Re: Rockville's Pike: Envision a Great Place
Rockville Pike Corridor Neighborhood Plan

Re: Rockville Pike Corridor Plan Update – 12303 Twinbrook Parkway (Lot 24, Block 7,
Halpine Subdivision)

Conceptual Design-Density Study

2.03b

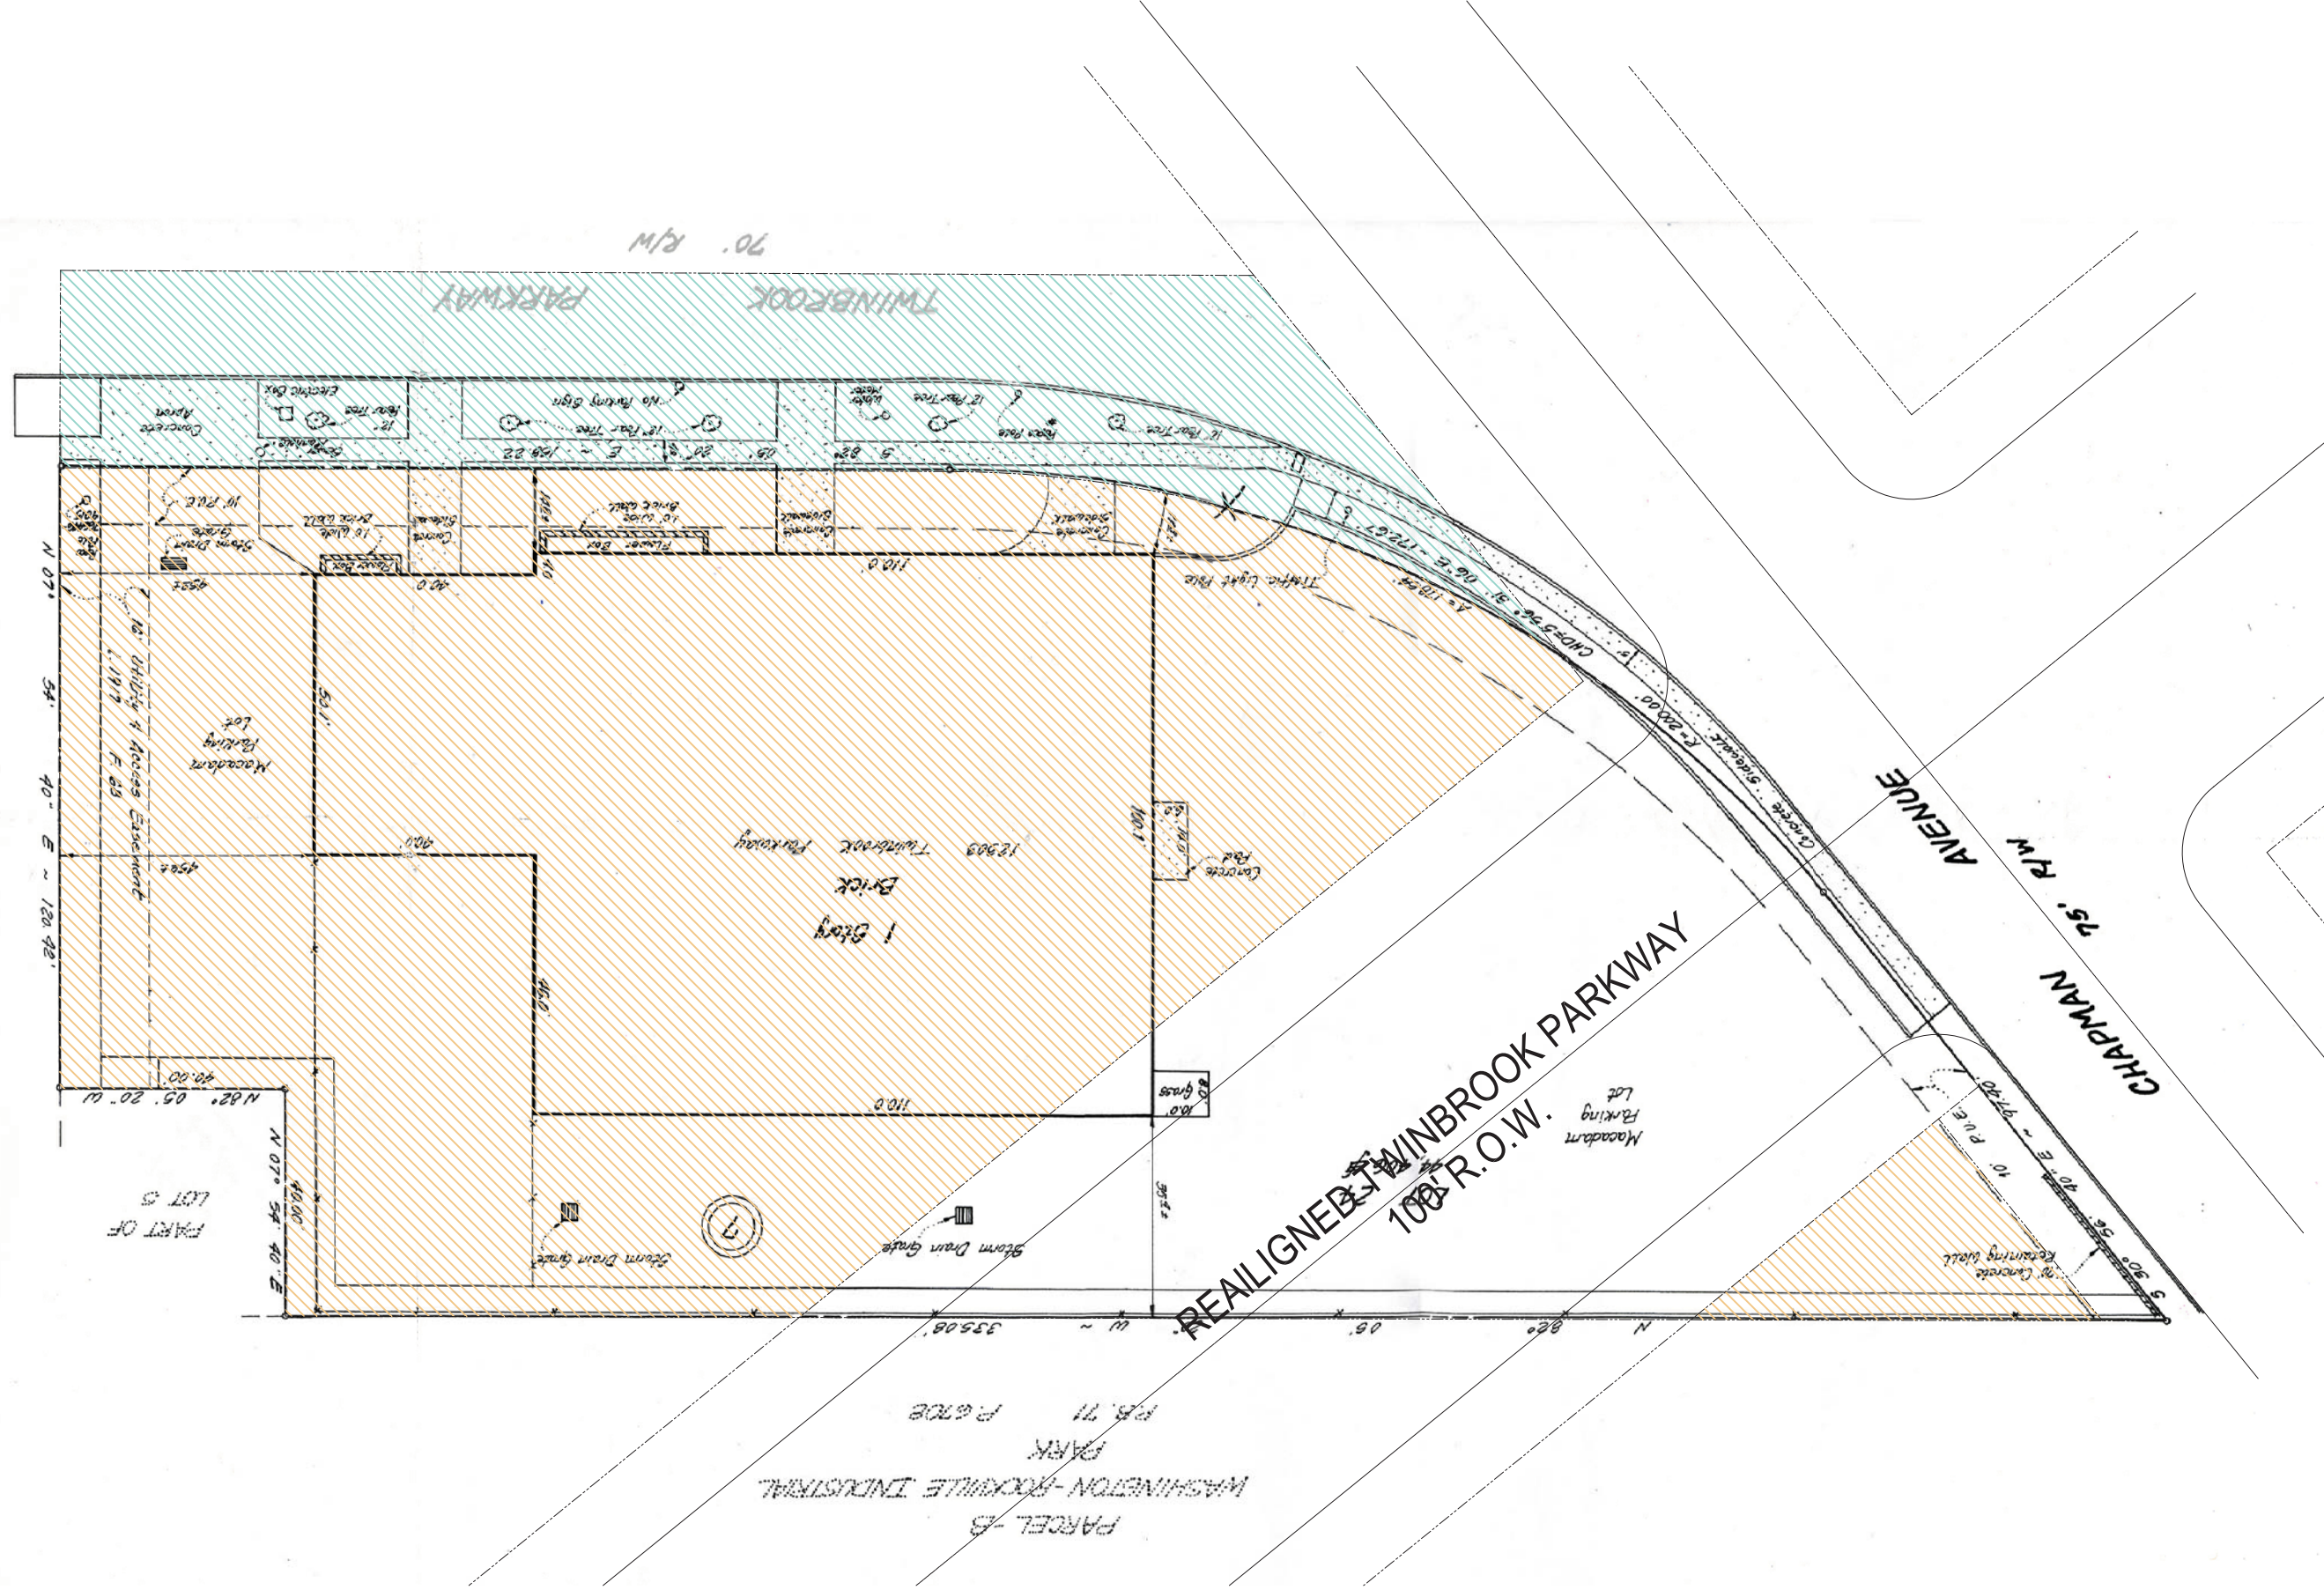
Option 2 considered by SKI would realign Twinbrook Parkway to line up with the existing signalized entrance to the retail centers fronting Rockville Pike. This realignment would still severely impact the Property and would create an unworkable situation for the existing restaurant and any subsequent tenants by eliminating the surface parking lot on the east side of the Property (and also requiring the likely demolition of the existing building). If such realignment were implemented, the Property could not be developed as described above. Some limited redevelopment potential might remain depending on the extent of construction/grading easements needed for the road realignment. However, the Realty Group advises such limited redevelopment's economic capacity to absorb the cost of the structured parking that would be needed to serve the Property is questionable.

realignment impact
proposal option 2
